ADELAIDE ROAD VENT SHAFT & HEADHOUSE

Visual Fact Check

Slides to illustrate HS2 misinformation to ECRG regarding visual impact
at meeting on 29th September 2022

“Revealing the Machine to create a Landmark to Celebrate this Outstanding Infrastructure Project”

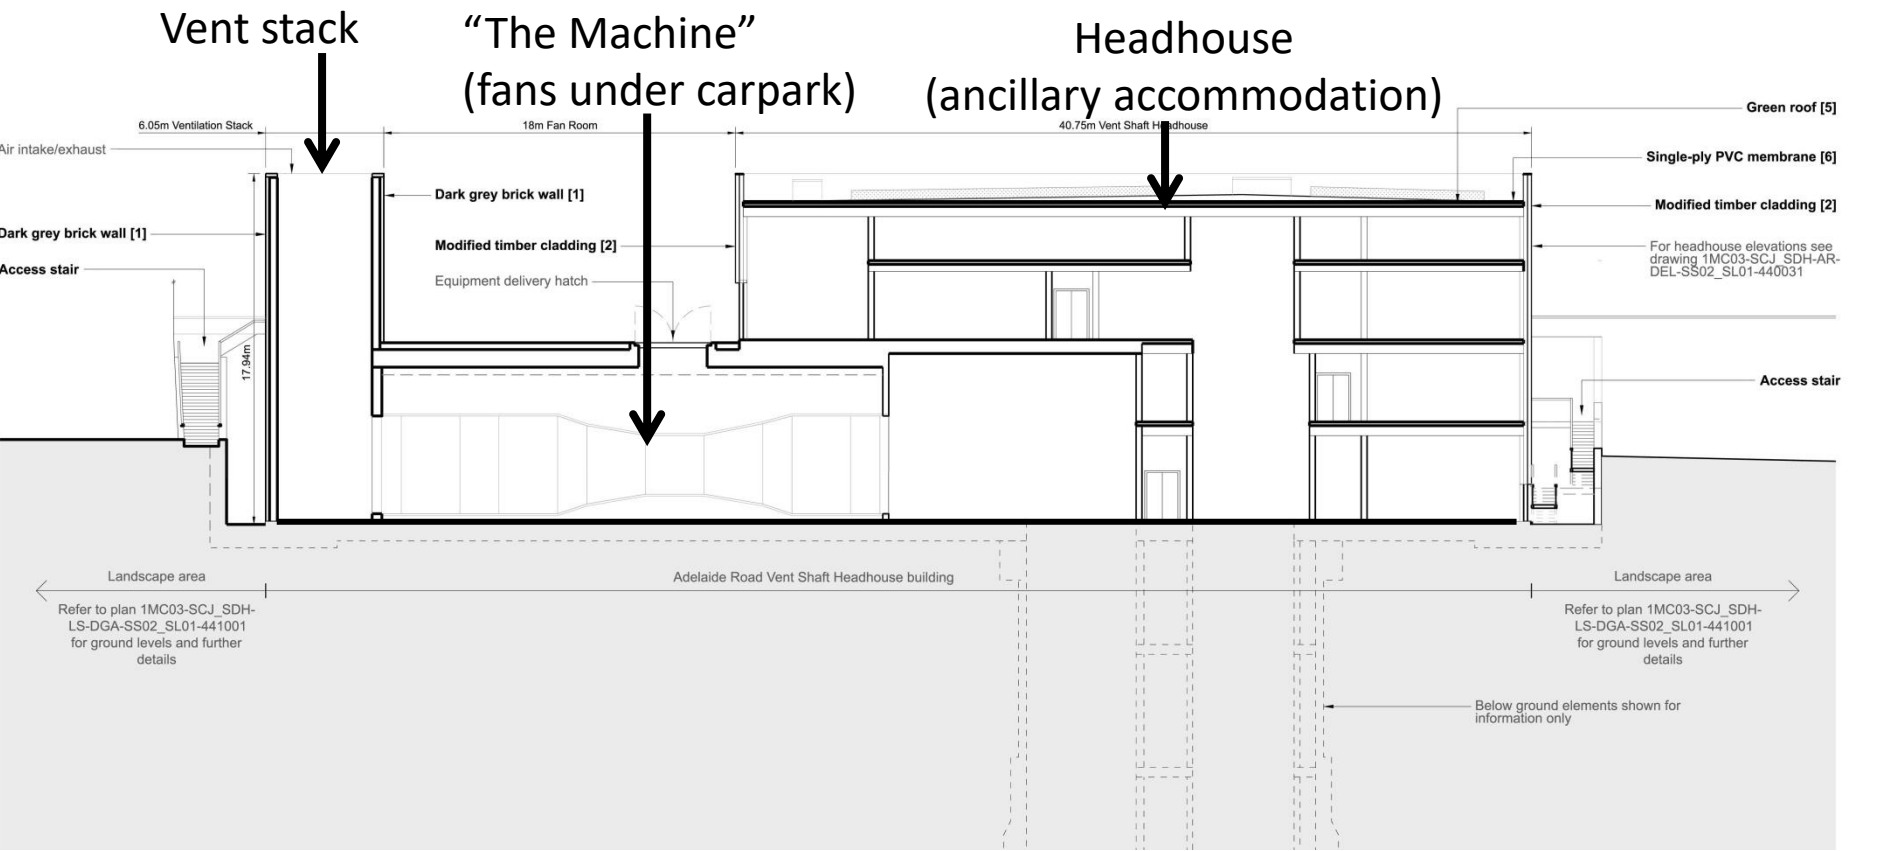
HS2 explained to ECRG that HS2 Independent Design Panel require a common design language of all headhouses called “Revealing the Machine” to express the engineering housed within them. So HS2’s family of headhouses will be identifiable (subject to variation to suit local contexts) The Design Panel Report published in Schedule 17 planning submission (as appendix to Design and Access Statement) commends the design of the Adelaide Road Headhouse for expressing its internal engineering within and “revealing the machine”. And it says that it should not be screened but should be a “landmark” for the local area “to celebrate this outstanding infrastructure project” and comply with HS2’s “Design Vision”.

But at Adelaide Road “The Machine” is outside the Headhouse, buried under the carpark. And its vent stacks are separate structures So at Adelaide Road the Headhouse contains ancillary accommodation (stairs, substation, staff facilities etc)... ie no “machine” within to reveal. Pretending to express “the Machine” visually externally (via brutalism) to appear like a generic HS2 vent shaft headhouse is clearly promotional. The Schedule 17 submission records that HS2 have rejected LBCamden’s request that the headhouse elevations should be articulated to reduce their scale (eg to match the nearby Victorian villas) and screened with green wall creepers on tension wires appropriate to its Nature Reserve location. Façade articulation could express the smaller ancillary accommodation within... in the absence of “the machine”!

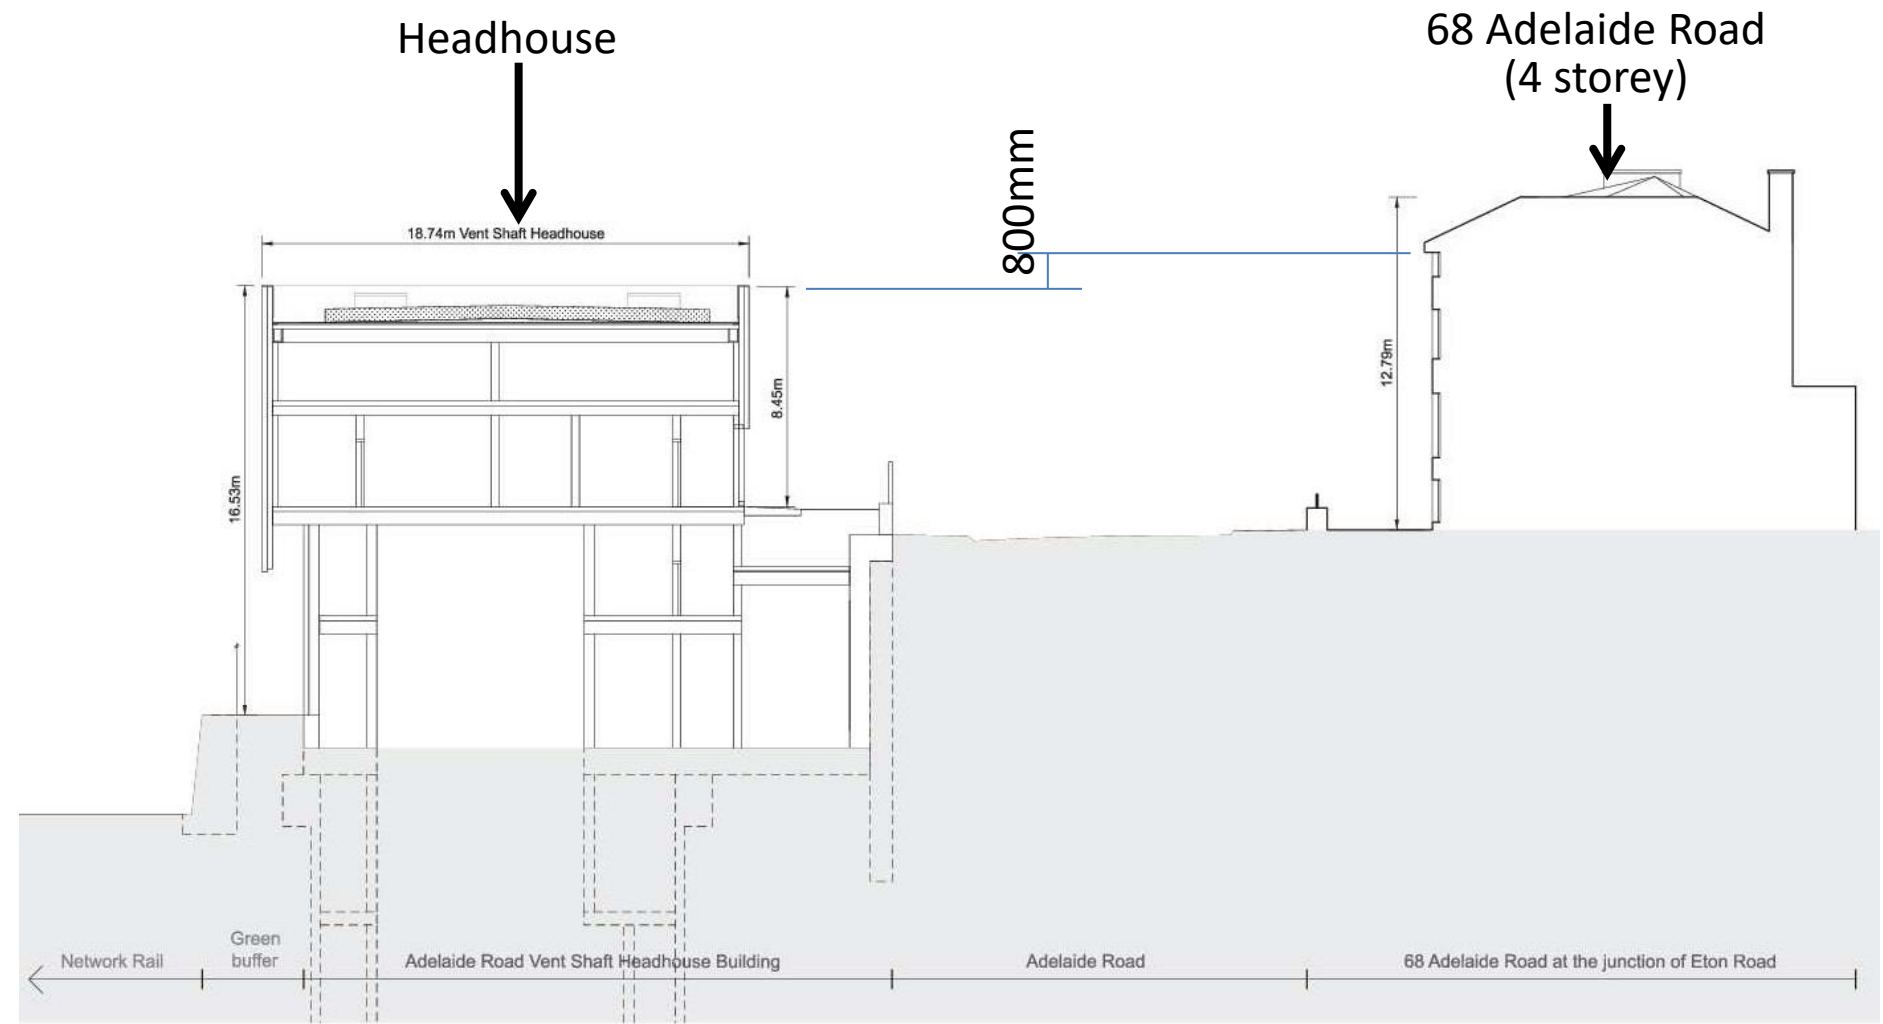
Schedule 17 drawing amended to show house across the road at the request of LBCamden
I annotate the two buildings and also headhouse parapet being only 800mm below house eaves
ie at 9.5 metres above pavement level it is almost the height of the 4 storey house façade
This permits HS2's denial of visual impact of the headhouse from the bridge to be checked.
(At ECRG HS2 insisted on describing the Adelaide Road elevation as "single storey")

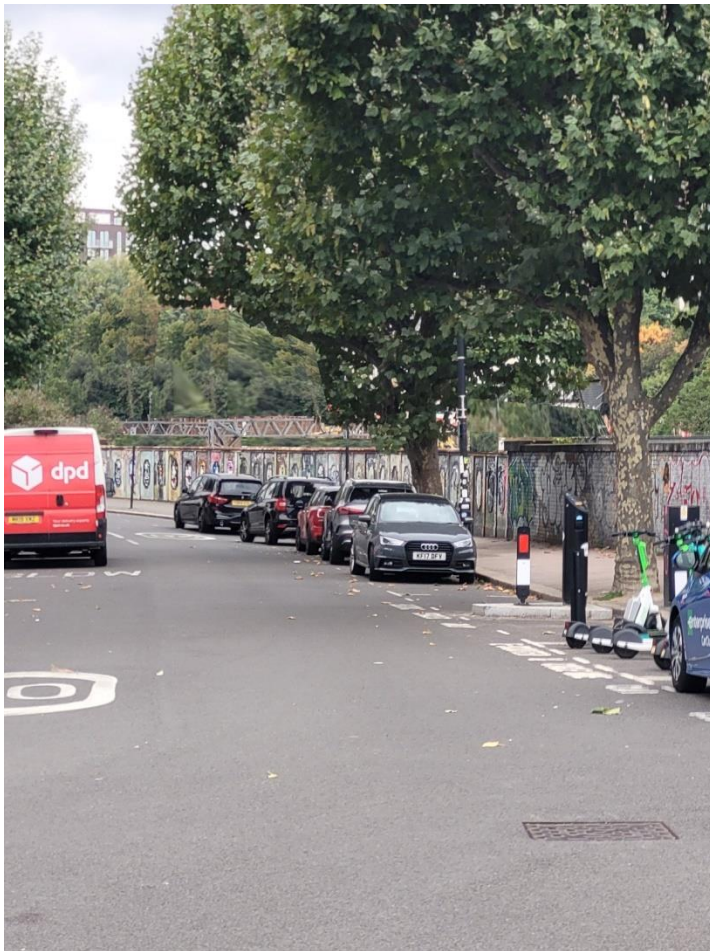
Current view from bridge with nearly all (500) trees removed so now No 68 can clearly be seen
So the headhouse can be drawn on this photograph (with its parapet level just below no 68 eaves in order to check whether HS2 were correct when they said their headhouse would cause no visual impact .. because it was concealed by the “6 foot high bridge parapet”.
The bridge parapet height actually measures 5ft9 at this point (measured directly below).
But it is 5ft4 above the bridge paving camber (where most people walk)

BEFORE shows the Chalk Farm Embankment Woodland Nature Reserve of over 500 mature trees clearly visible as the green backdrop over the parapet of the bridge (which is the main tourist route to Primrose Hill).

AFTER shows the headhouse and vent-stacks (in red) replace most of the woodland and hide the remaining trees behind. Massive visual impact occurs above the bridge parapet line as the headhouse size and unscreened elevations fill the view

2 South Elevation
A43032

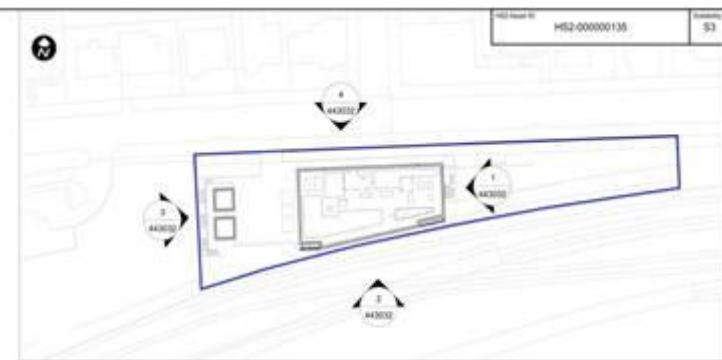
4 STOREY BUILDINGS BEHIND ARE DRAWN AS 5/6 STOREY.. (VENT SHAFT IS SAME HEIGHT)

VENT SHAFT ALMOST SAME HEIGHT AS 4 STOREY ADELAIDE ROAD VILLAS

PRIMROSE HILL BUILDINGS BEHIND ARE ACTUALLY SAME HEIGHT AS VENT SHAFT

FIDDLED ELEVATION

DISTANT EXISTING NATURE RESERVE TREES OVER 100 METRES BEHIND DRAWN 3X SIZE

DISTANT TREE ADDED

IMPOSSIBLE TREE

THE CONVENTION IS TO SHOW DISTANT TREES ONLY IN OUTLINE WITHOUT COLOUR. IN PERSPECTIVE (SO FAR BACK) THEY WILL APPEAR TINY

THIS IS NOT THE VIEW FROM PRIMROSE HILL BRIDGE ALMOST NO TREES WILL BE VISIBLE FROM BRIDGE

Proposed landscape layout at scheme design

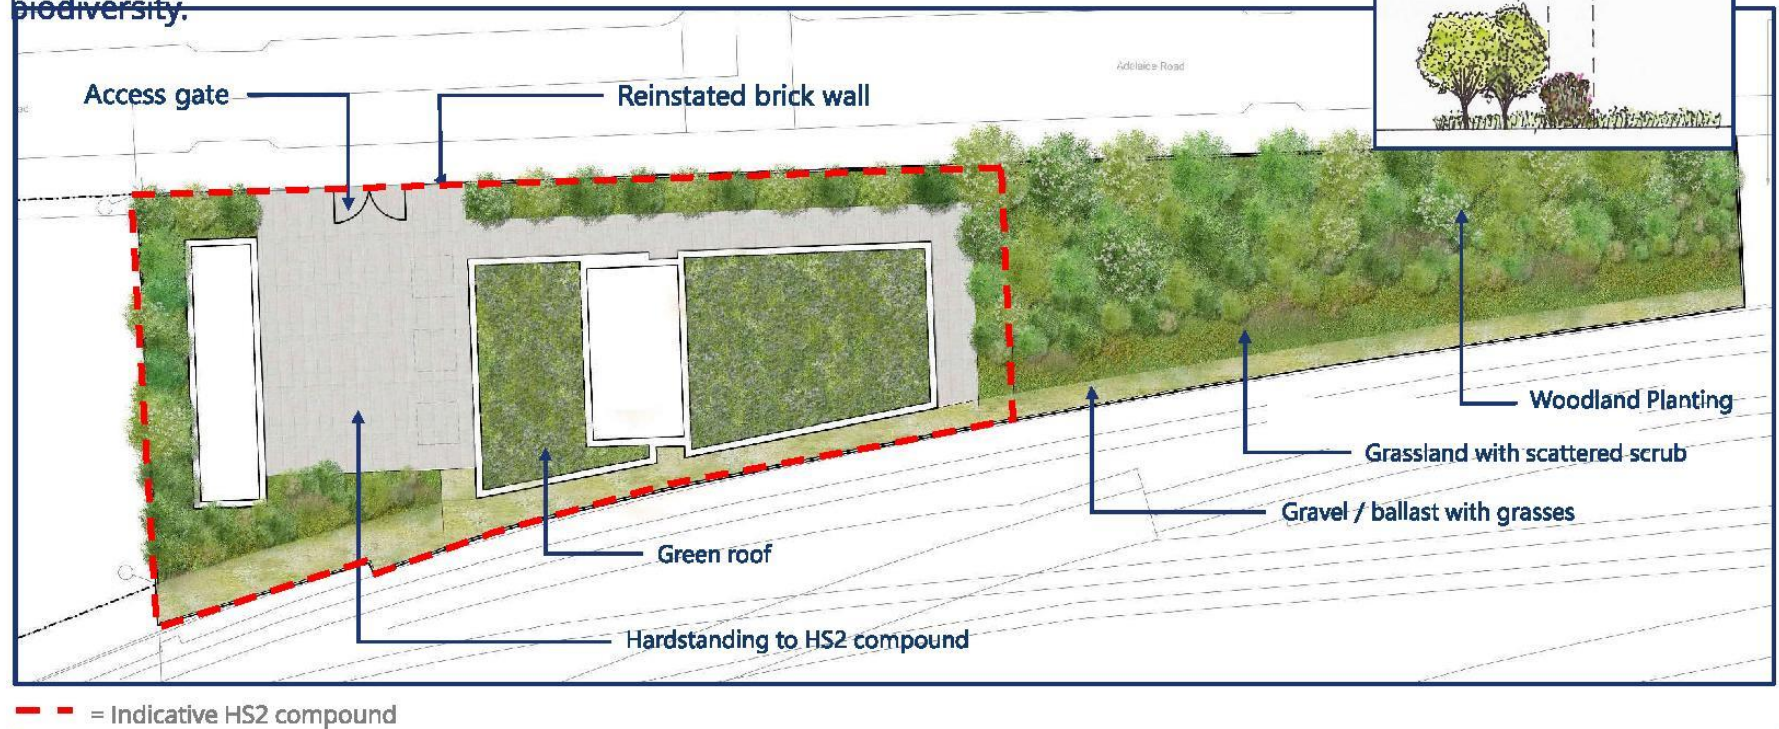
This plan and section shows that HS2 graded landscape concept. HS2 explained NR would not permit tree planting in proximity to their existing retaining wall. This greatly limits the possibility of trees being replanted to screen the vent shaft from the south and east.
